BOARD ACTION REPORT – APPEALABLE ITEM

Project Name: 142 NE 7th Ave

Request: Class V Site Plan, Architectural Elevations, Landscape Plans

Board: Site Plan Review and Appearance Board

1 FIRST FLOOR PLAN/SITE PLAN
SCALE: 1"=10'-0"

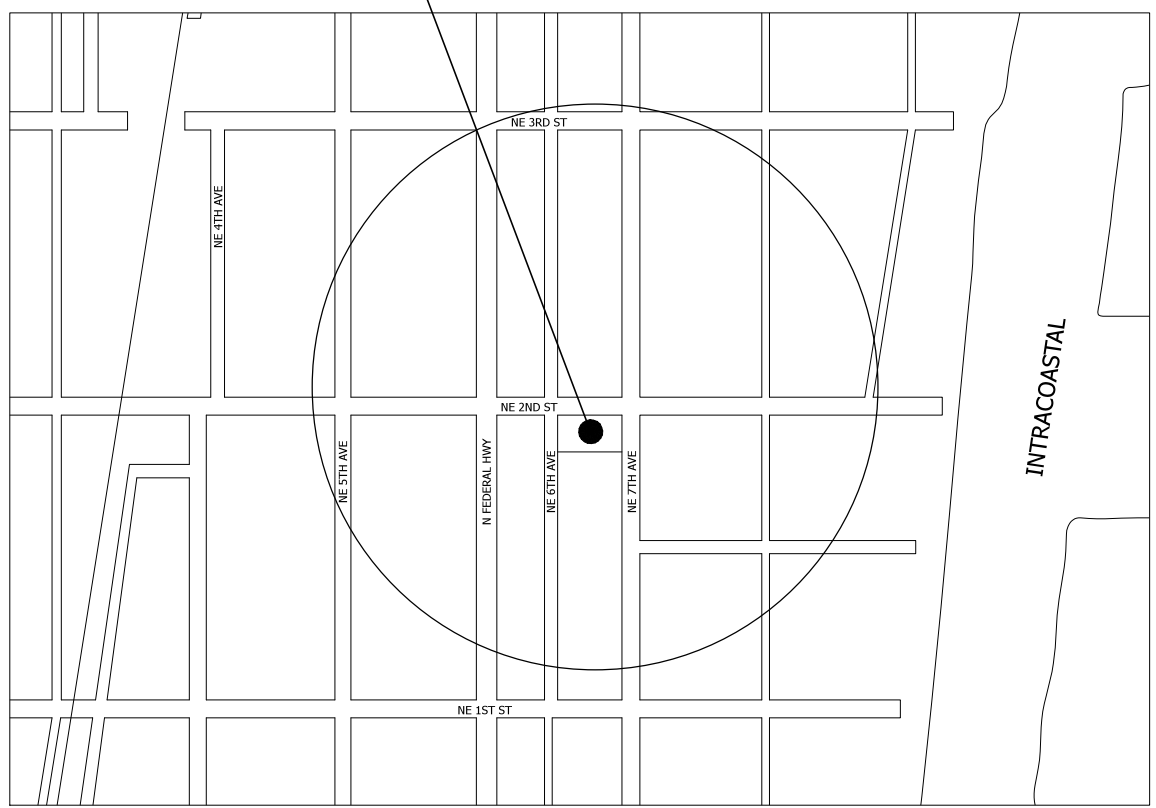
When an access way intersects a public right-of-way, triangular areas shall provide unobstructed cross-visibility. The area on both sides of a driveway formed by the intersection of a driveway and a street with a length of ten feet along the driveway, a length of 10' along the street right-of-way and the third side being a line connecting the ends of the other two lines. Visibility triangles for the four outer edges driveways along the street rights-of-way have been depicted and comply with this LDR requirement. **Prior to plan certification, the landscape**

“island” between the driveways of all units shall have the sight visibility triangle shown on the site plan and landscape plans.

3. Prior to building permit issuance, the plat and any maintenance agreements must be recorded.
4. Prior to site plan certification, the dimension of 60'-0" Right of Way near the existing driveway label will be revised to read 55'-0".

5. Prior to site plan certification, the civil and site plan drawings will be updated to show the new location of the proposed sidewalk along 7th Avenue as shown on the landscape rendering submitted October 24, 2018, removal of proposed parallel parking along 2nd Street to be replaced with a landscaped strip, and curb and gutter shown along the site frontage on NE 7th Avenue and NE 2nd Street. Civil drawings will be approved by the City Engineer prior to site plan certification.
